HARRISVILLE CITY

Harrisville City Planning Commission

Wednesday, April 14, 2020 – 7:00 p.m.

Harrisville City Planning Commission Staff Report

Exhibit H: Landscape Plan

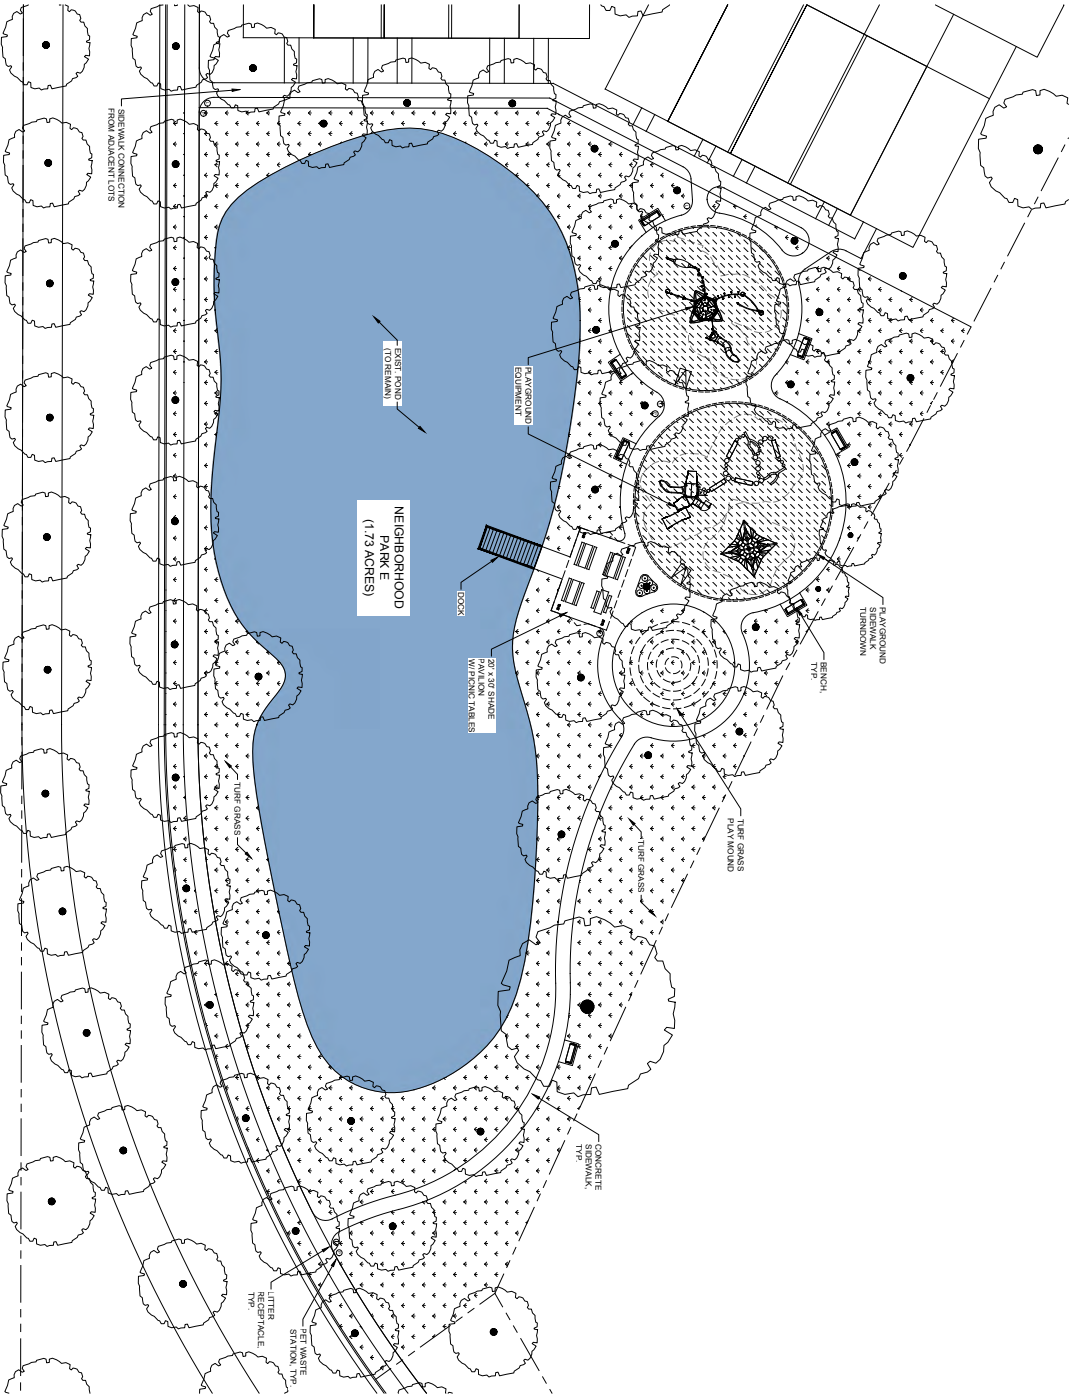
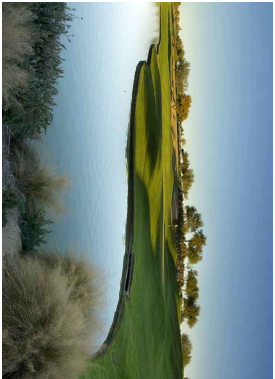
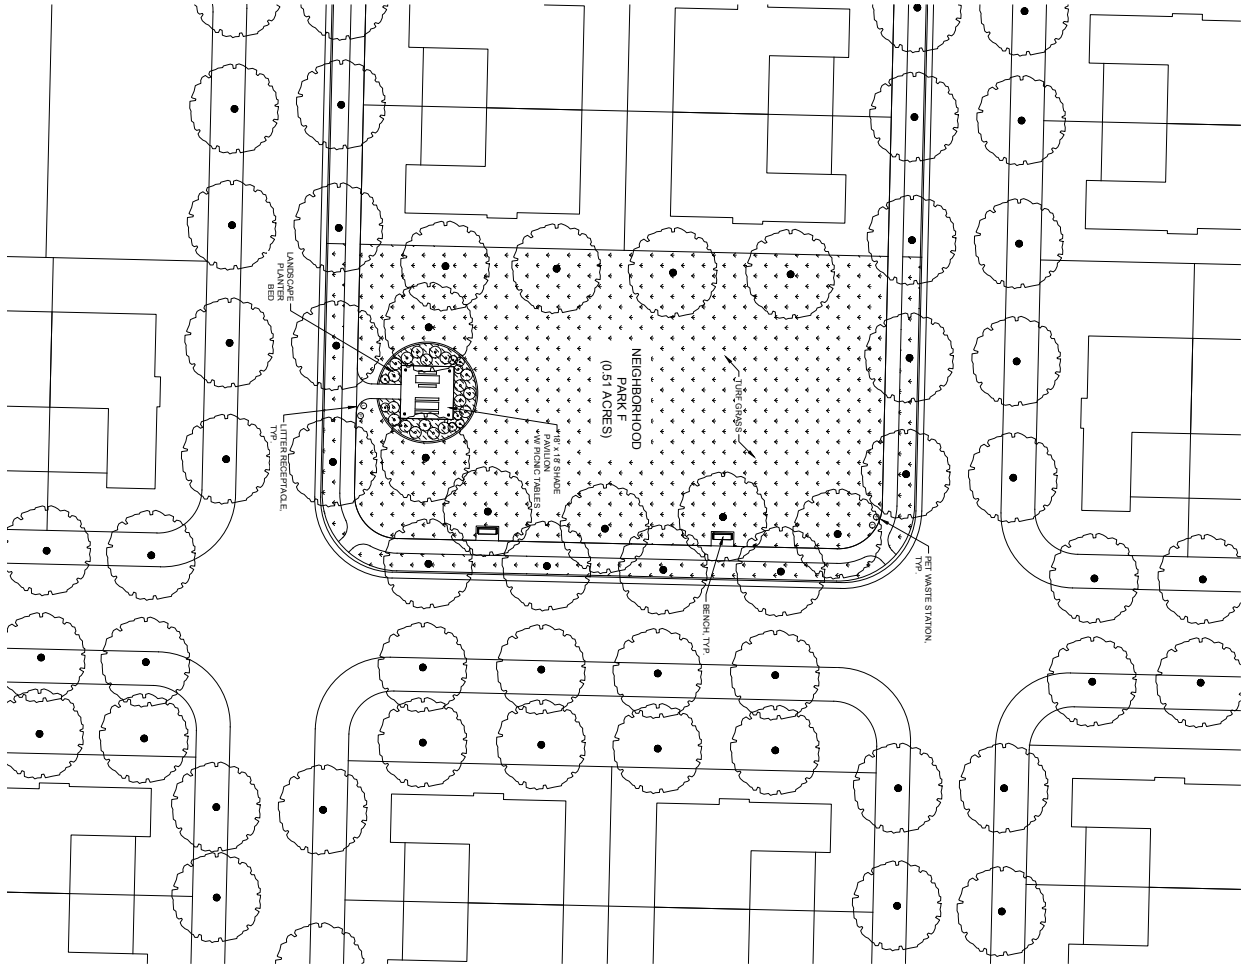
One of the neighborhood parks that has been identified as a “Neighborhood Park” on the Master Plan (see Exhibit A) and on the Park Plan (see Exhibit M) has been left off the Landscape Plan. The park in question is the park with the smaller pond located near the twin home section of the village in Phase 6b and is approximately 1.37 acres in size (see Exhibit L). A condition of approval has been added to staff’s recommendation that a Landscape Plan is submitted for review and approval for “Park G” located by the smaller pond. This is being done to ensure that an adequate Landscape Plan is incorporated into the MDA.

With the upgrades to Millennium Park and the additional neighborhood park added to the developer’s calculations of Parks A-F in the Landscape Plan (see Exhibit H) currently totaling 12.13 acres dedicated for parks, we can more correctly be looking at approximately 21 acres of open space dedicated to parks for Harrisville City due to the agreement that the City has undergone with the developer for the continual care and maintenance for Millennium Park. These details regarding the care and maintenance of the park are being worked out currently in the MDA which will grant a perpetual easement for the care and maintenance of the park and it will set up the stipulations on how the park will be managed due to the park being a public park. Further documentation will be going into the CC&R’s regarding the care and maintenance for all the parks, including Millennium Park. Repairs are going to be made to Millennium Park that include repairs to the ditch that is causing flooding, a new parking lot, upgrades to the restrooms and new playground area.

1. A corrected Landscape Plan that shows the landscape design for Park “G” and Millennium Park.
2. The developer will continue to work with the work committee and Planning Commission to receive input for the design of the commercial village which includes the condominiums.
3. Landscape and fencing design for the area between Hwy 89 and the Ben Lomond View buffer area as well as the landscaped buffer area along the main road will be submitted for review and approval.

12. Twins (Senior Targeted) Homes

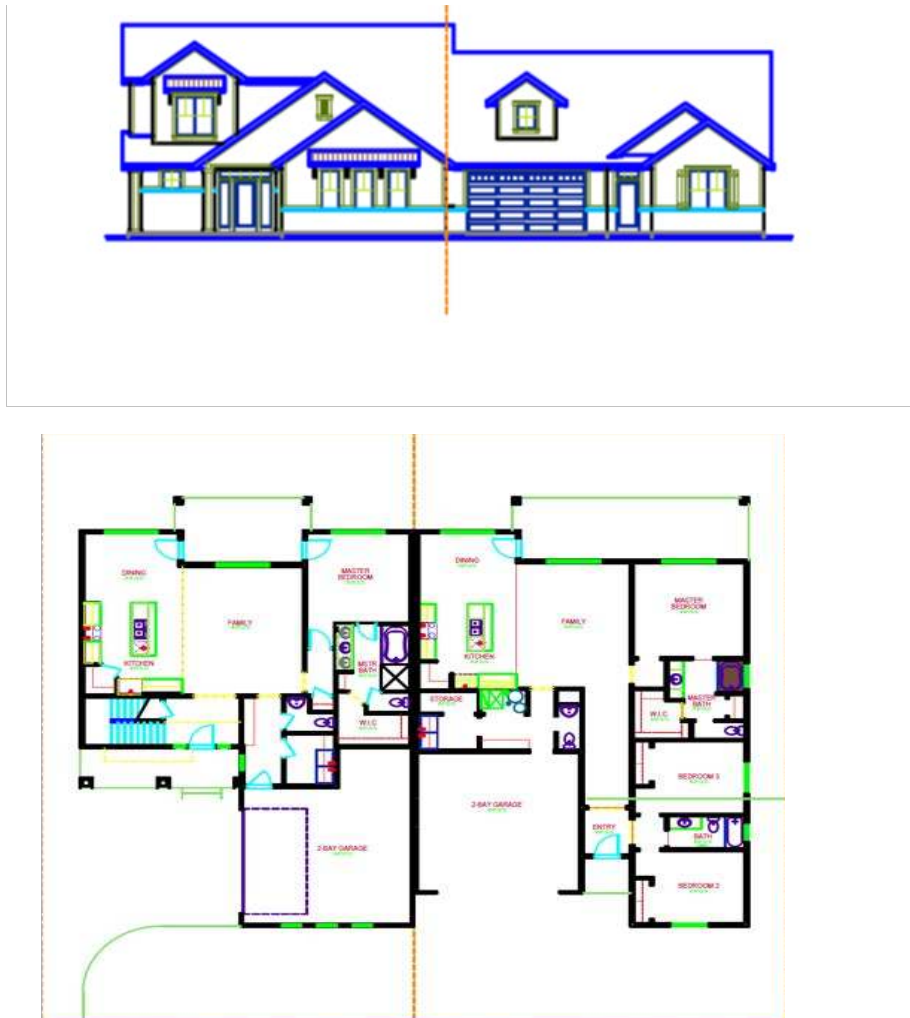
The Twins 2-family home above will be re-designed with 1 garage door facing the street and 1 side entry garage door. One or both front entry doors will also be relocated to the front elevation. A line drawing and plan showing the preliminary new layout is below.
